Our reference: P-22226

7 June 2023

**RESPONSE TO SYDNEY NORTH PLANNING PANEL DEFERRAL  
S4.55(2) MODIFICATION TO DA117/2017 - 266 LONGUEVILLE ROAD, LANE COVE**

Figure 1: Extract from LA02 Prepared by TaylorBrammer, Ref. Job No: 16-162s, dated 21-10-22

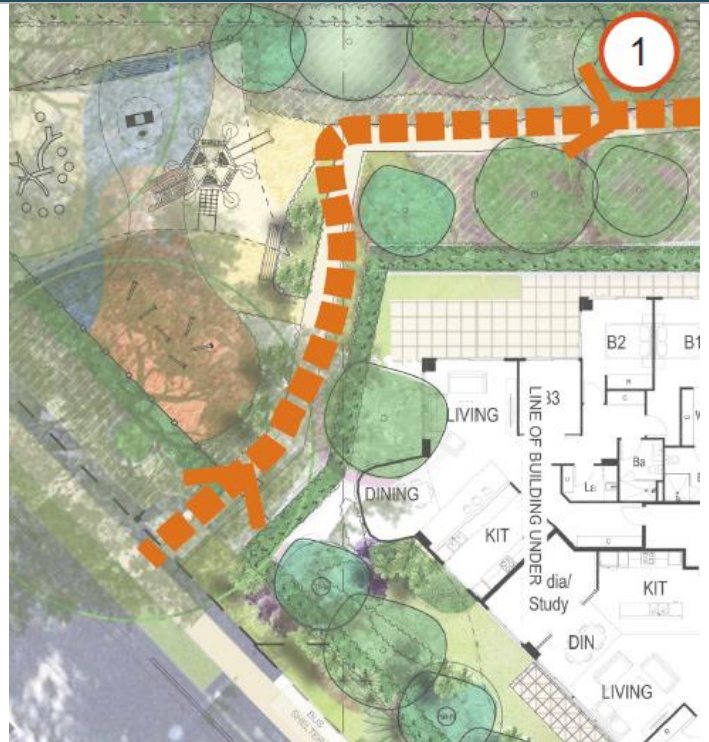
<p>6. <i>Clarification of changes to balconies and privacy arrangements;</i></p>	<p>*See below.</p>
<p>7. <i>Refinement of conditions relating to location of the substation and public access for the through site link.</i></p>	<p>Development Consent DA117/2017 (as modified on 30 November 2022) provides conditions relevant to substation as follows:</p> <p><i>62. The electricity kiosk shall be positioned in "substation location 2" marked on the diagram attached to the letter prepared by GSA Planning dated 8 June 2018, i.e. inside the Longueville Road boundary approximately half-way between the porte cochere entry and the public park, subject to the approval of the electrical utility provider.</i></p> <p><i>126. Screen planting is required to soften the electrical substation. These plants must be healthy, good quality nursery stock, planted at a minimum 45L pot size, being free of girdling roots and other defects and be at least</i></p>

RFI MATTER	APPLICANT RESPONSE
	<p><i>2m tall above the ground at time of planting with a height at maturity of at least 3 m tall. Plants must be spaced 1.5 m apart at planting. Species selected are to be locally native. A species list of local native plants is available from Council.</i></p> <p>The proposed changes to the Conditions provided by Council's Independent Assessor of the subject application sought to modify Condition 1, 62 &amp; 126 as follows:</p> <ol style="list-style-type: none"> <li><i>1. References proposed Architectural &amp; Landscape plans modifying location of substation.</i></li> <li><i>62. The electricity kiosk shall be positioned within the Longueville Road frontage of the site as shown on the Morrison Design Partnership Plan DA.050, Revision DA.1, dated 22/10/22 or as otherwise directed by the electricity service provider. (Amended 17 May 2023)</i></li> <li><i>126. No Change</i></li> </ol> <p>In response to this matter, please see a copy of a report prepared by Edgewater Connection dated 26 May 2023 attached to this correspondence.</p> <p>The key message derived from the Edgewater Connection advice is that the design and location of Substations must meet specific Ausgrid design requirements. There are several site constraints impacting the substation location. The proposed location of the substation is the most suitable based on:</p> <ul style="list-style-type: none"> <li>• <i>24/7 direct unimpeded access from public road.</i></li> <li>• <i>Suitable clearance from building and essential services.</i></li> <li>• <i>No impact on existing trees.</i></li> <li>• <i>No impact on proposed residents for noise and electromagnetic fields</i></li> <li>• <i>No impact on access requirements for fire brigade</i></li> <li>• <i>No impact on building use due to construction segregation requirements such as fire and ventilation.</i></li> </ul> <p>In the context of the technical requirements for the siting of substations, it should be noted that the location of the proposed substation to the northwest corner of the site will have no impact on public access to the children's play area of the through site link and it will be installed in a landscape setting to minimize visual impact.</p> <p>In this regard, I draw the SNPP attention to the submitted landscape plans LA02 - LA05 Prepared by TaylorBrammer, Ref. Job No: 16-162s, dated 21-10-18 which provide detail on the site link location and proposed plantings. Relevant Extracts from the landscape plans identify the following:</p> <p>Site Link Path is situated between the children play area and the northwest building elevation – see below:</p>
